INTER-OFFICE MEMORANDUM

SUBJECT: §5-58 of the City of Newton Ordinances, request for site plan approval to renovate and add to Cabot Elementary School with related site improvements

MEMORANDUM

Re: Cabot School

Proposed site plan

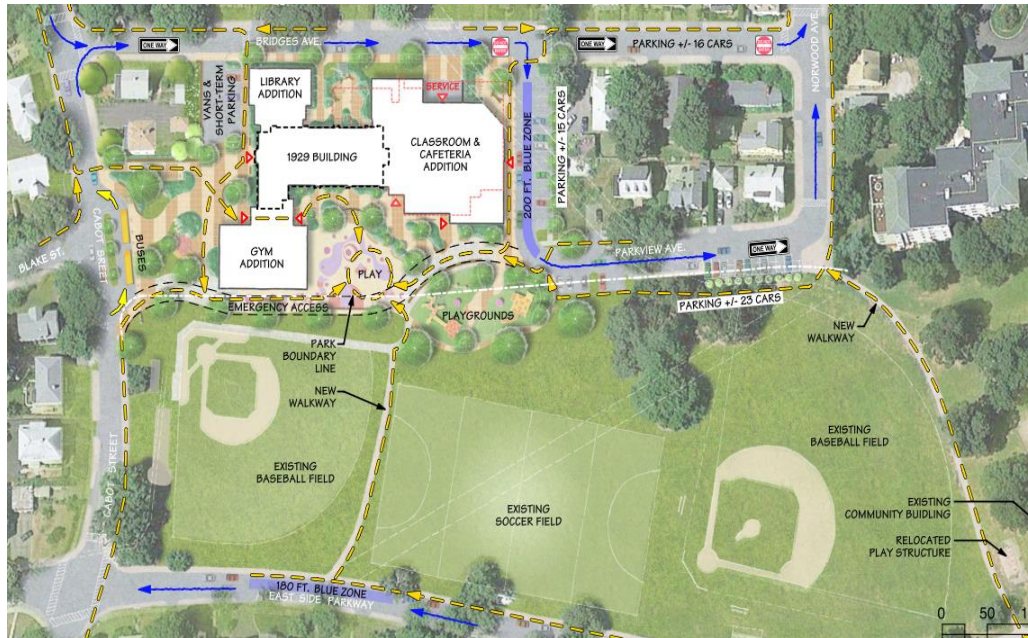
School bus access will be limited to a circular entry drive for pick-up/drop-off at the south side of the school. Vehicular access by school staff will be at the north side where long-term staff parking will be available. The proposed location and increase in spaces will be an improvement over the existing conditions, and ensure that this portion of the site will be the least trafficked area during the school day. With the closure of a portion of Parkview Avenue and removal of the house at 23 Parkview Avenue, vehicular access to the site will be improved with one-way access to Bridges and Parkview Avenues.

Short-term and handicap-van vehicular parking for parents and caregivers will be available on Bridges Avenue. Sidewalks and wayfinding signage will enhance the safety of pedestrian circulation. Several new crosswalks from all perimeter streets will be added for students

walking to school and will have high visibility for both walkers and drivers. The Planning Department believes that the on-site vehicular and pedestrian circulation plan as proposed will be a marked improvement over existing conditions and will accommodate the anticipated increase in the need for parking.

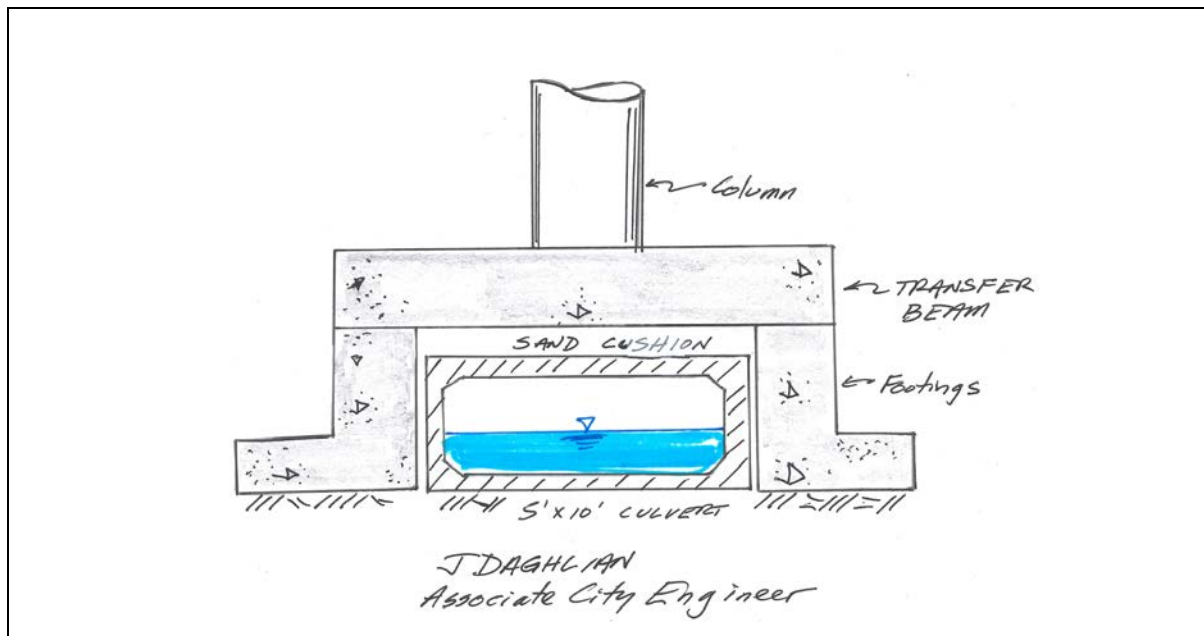
The site also is traversed by a major drainage structure a (5' x10') concrete box culvert that contains Laundry Brook. This culvert receives substantial portion of all the stormwater drainage from Newton Centre and directs it to the Charles River. The plans indicates that the building's footprint (northwest) corner will be positioned up to the drainage easement on the ground level, then the 2nd floor will overhang the drainage easement and will have a support column that will be positioned over the culvert. The DPW's Utilities Division has a consultant designing a culvert replacement that is staled to be bid during the spring of 2017, with construction occurring the summer of 2017. The coordination of the culvert replacement & school construction was brought to the attention of the design team about a year ago. A structural design will be needed for the proposed support column that will be placed directly above the box culvert. The loads from the building will have to be diverted beyond the cross-section of the culvert so that no loads bear on the culvert [see schematic below].
